**Monks Orchard Residents' Association  
Planning**

24<sup>th</sup> July 2019  
Emails: [planning@mo-ra.co](mailto:planning@mo-ra.co)  
[chairman@mo-ra.co](mailto:chairman@mo-ra.co)  
[hello@mo-ra.co](mailto:hello@mo-ra.co)

<b>Reference:</b>	<b>19/03064/FUL</b>
<b>Application Received:</b>	<b>Mon 01 Jul 2019</b>
<b>Application Validated:</b>	<b>Thu 11 Jul 2019</b>
<b>Address:</b>	<b>37 Woodmere Avenue Croydon CR0 7PJ</b>
<b>Proposal:</b>	<b>Demolition of existing dwelling. Erection of two storey building (with roof-space accommodation) comprising 8 flats (1 x 3 bed, 5 x 2 bed and 2 x 1 bed) with associated car parking, amenity space and cycle and waste stores.</b>
<b>Status:</b>	<b>Awaiting decision</b>
<b>Case Officer:</b>	<b>Paul Young</b>
<b>Consultation Close:</b>	<b>Sun 04 Aug 2019</b>
<b>Deadline determination:</b>	<b>Thu 05 Sep 2019</b>

**Illustration of excessive PTAL Requirement above the Local available PTAL due to Increased Densities of Applications in the MORA Post Code Area showing the ongoing PTAL linear trend requirement. (This most recent application circled)**

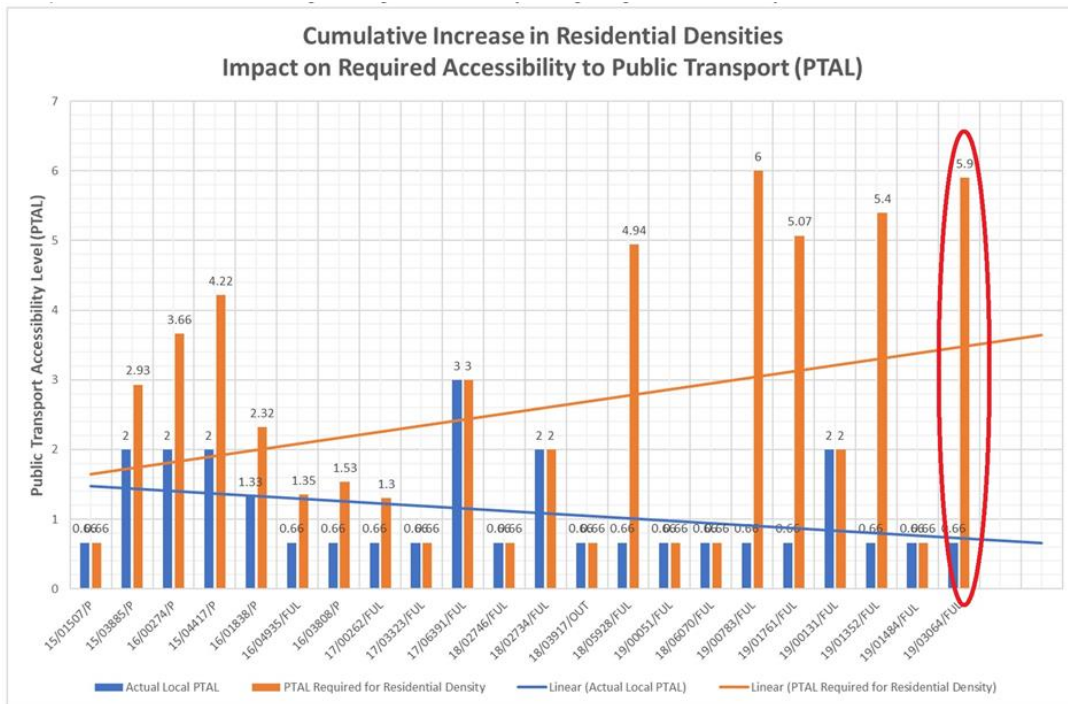
If the PTAL between 0 and 2 is assumed linear the PTAL 1a = 0.66 and PTAL 1b = 1.33. Then it can be shown above at an extract from the London Plan Density Matrix Table 3.2 at a **suburban setting** to illustrate that the **Residential Density** of the proposed development is **totally inappropriate at 342.86hr/ha** for the locality which has a **PTAL of 1a (≈0.66)** when it **actually requires a PTAL of 5.9** in the ranges 4 to 6 shown on Table 3.2.

Similarly, a **Housing Density of 91.43 u/ha** is totally inappropriate for a locality of PTAL 1a which would actually require a **PTAL of 4.713** – in the highest range **4 to 6**, but the locality has a **PTAL of 1a** in the lowest range at a suburban setting. The appropriate ranges for Housing Densities at this setting and **PTAL of 1a** with an average of **3.75 hr/u**.
